**INTERNATIONAL CODE COUNCIL
2012/2013 CODE DEVELOPMENT CYCLE
Group A (2012)**

**PROPOSED CHANGES TO THE
2012 EDITIONS OF THE**

INTERNATIONAL PLUMBING CODE[®]

**April 29th – May 8th, 2012
Sheraton Dallas Hotel
Dallas, TX**

Figure 4 – Example of Water heater Thermostat setting verses HW outlet temperature at the top of the heater.

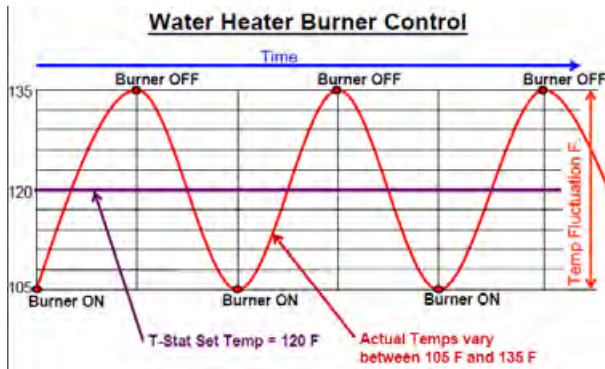
With "Thermal Layering", you can get Scalding Hot Water out of an Un-circulated Storage Type Water Heater with the Thermostat Set at 120 F

Figure 5 – Illustration showing how stacking or thermal layering

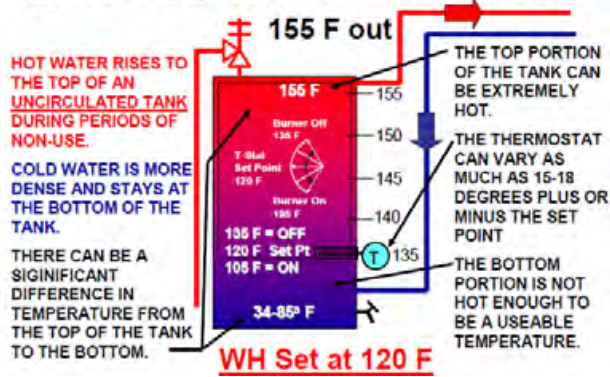
This figure shows how the hot water at the top outlet of a water heater can exceed the thermostat setting near the bottom of the water heater.

Use ASSE 1017 Thermostatic Mixing Valves at the Water Heater or ASSE 1070 valves at the point of use!
